HUM PROBLEMS WHEN SWITCHING THE K9AY LOOPS

By Gary Breed, K9AY, 2395 Camp Mitchell Rd, Grayson, GA 30017, e-mail gary@noblepub.com

Figure 1—A revision of the schematic shown in Figure 5 of the September 1997 *QST* article.

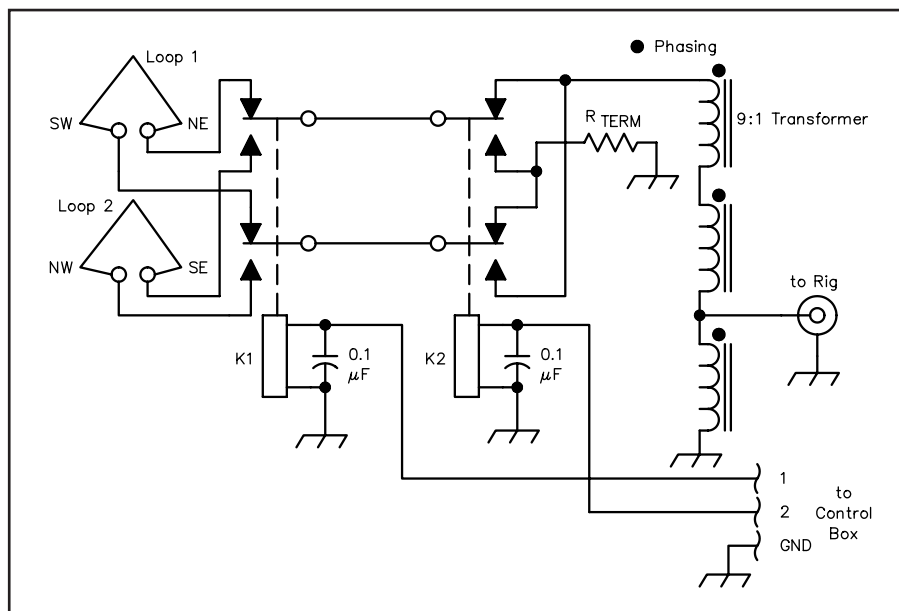
There is one problem that needs to be addressed. When the loops are switched to the northwest direction, an ac voltage is sent down the coax to the relay box. A few hams have reported hum or distortion when the antenna is switched in this direction. Two explanations are possible: a ground loop due to widely separated antenna and station grounds, or modulation of the core of the matching transformer. The presence of hum was not evident in my prototype, but to avoid either cause of the problem, I recommend using a *separate* three-conductor control wire to operate the relays. The power is solely 12 V dc, and no current flows through the transformer. The modifications are shown in the accompanying figures, which can replace Figures 5 and 6 in the original article.
